Conservation Commission / Inland Wetlands Agency

REGULAR MEETING MINUTES

(IW 20-116) Oxford Enterprises, LLC, 3 Woodruff Hill Rd, (Map 25, block 22, Lot 13-5) proposed use Industrial building, grading, upgrades of drainage. Total size of site 75 acres (Total acres of wetlands= 5.73 acres) (Wetlands impact = 0 acres) (Upland review area impact = 15,860 sq. ft.) (amount of material removed= 1200 c.y.) (Deposited= 60 c.y.)

RE: #3 Woodruff Hill Road (Lot 5) & #7 Woodruff Hill Road (Lot 6)

PICTURES OF ON-SITE WETLANDS AREA SOUTHEAST OF LOT 5 DEVELOPMENT AREA

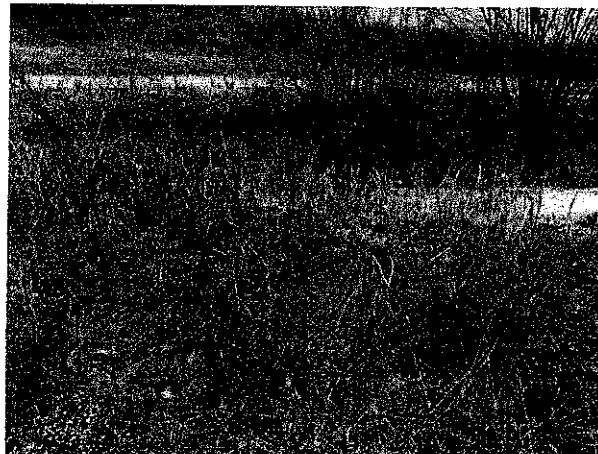
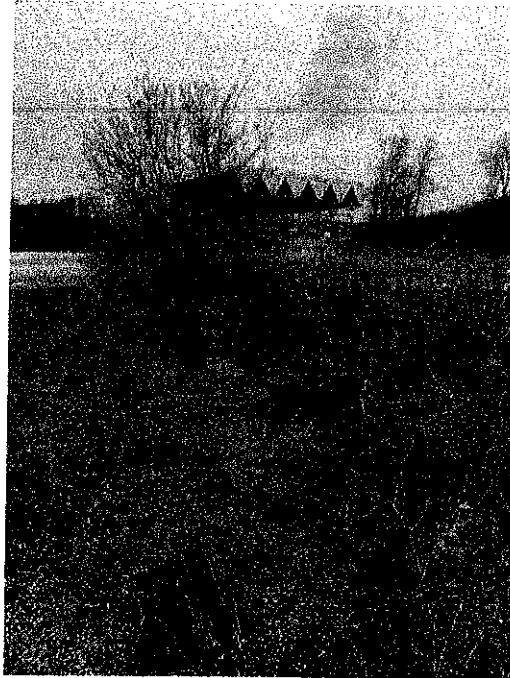
C9) Please provide information on the inland wetland on this site.

R9) The inland wetlands as shown were flagged and located as part of the Woodruff Hill Industrial Park Subdivision plans. Grading and filling adjacent to the wetlands areas was previously completed during construction of the lay down areas for the construction of the Towantic Energy Plant. The site development plans as presented are consistent with the conceptual plans for the area that received Inland Wetlands and Watercourses approvals during the subdivision process.

Prior to construction, orange construction fencing will be installed around the isolated wetlands area southeast of the development for identification and protection. Additionally, limits of construction and proposed silt fence locations will be staked by a licensed surveyor prior to construction. Two pictures of the current condition of this wetlands area have been included at the end of this response letter.
